Proposal for Frame Processing Simplification by applying WEP to MPDU payload rather than MSDU payload.

**David Bagby
Advanced Micro Devices
7 July 1995**

That WEP processing be changed from an MSDU basis to an MPDU basis by adopting the changes shown to D1.2, said changes to be reflected in the next draft standard revision.

Figure 5-4: Construction of expanded WEP MSDU

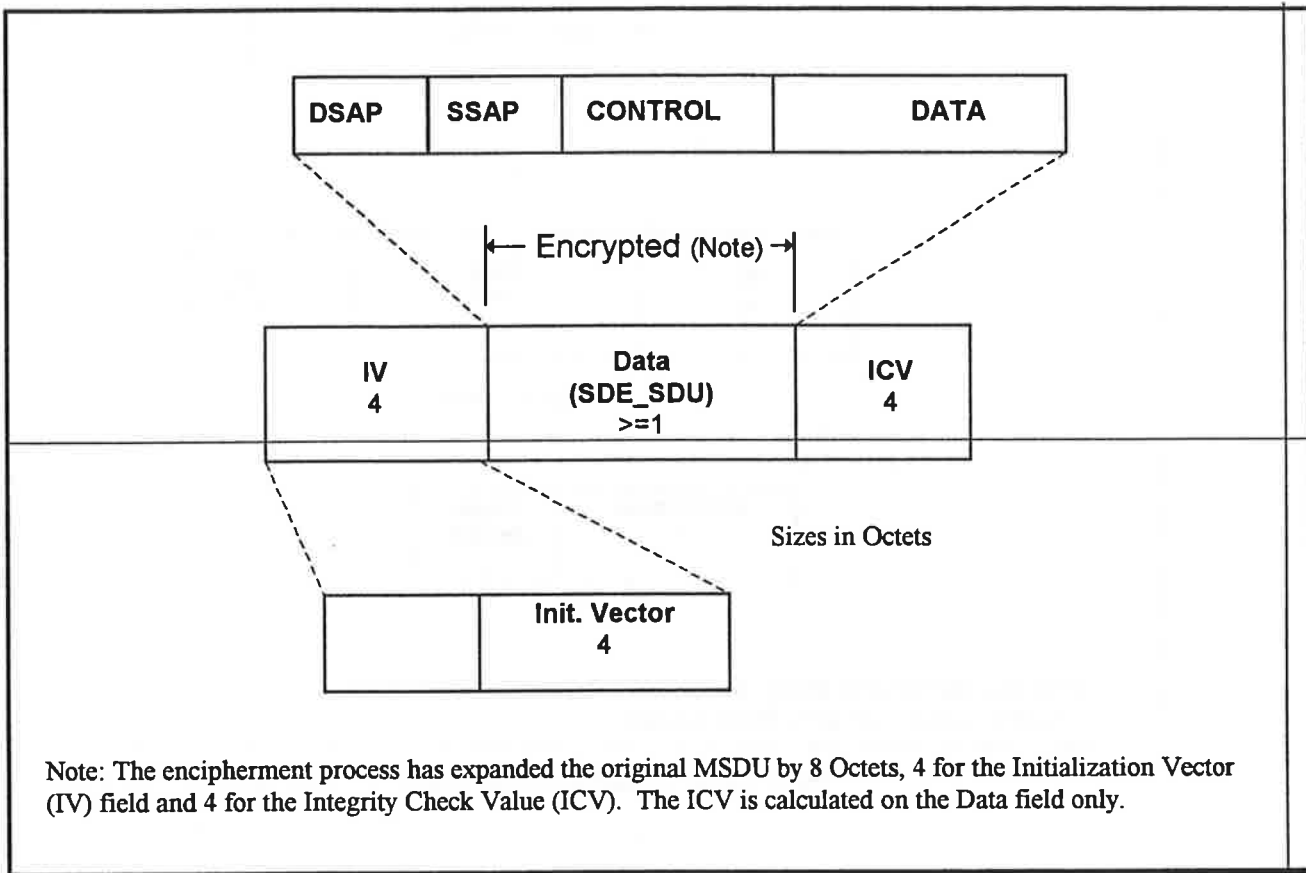
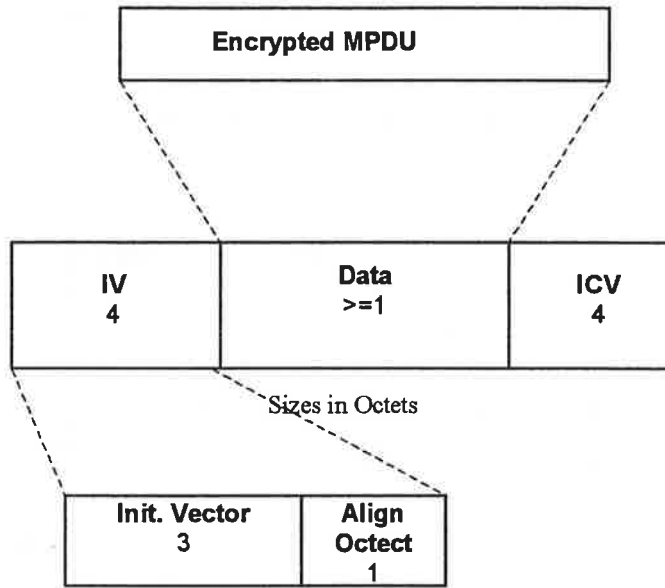
Figure 5-4 shows the encrypted MPSDU as constructed by the WEP.

The WEP ICV = 32 bits. The expanded MPSDU shall include thea 32-bit-IV field immediately preceding the encrypted MPSDU.~~This field shall contain one sub-field: A 4 octet field that contains the initialization vector.~~
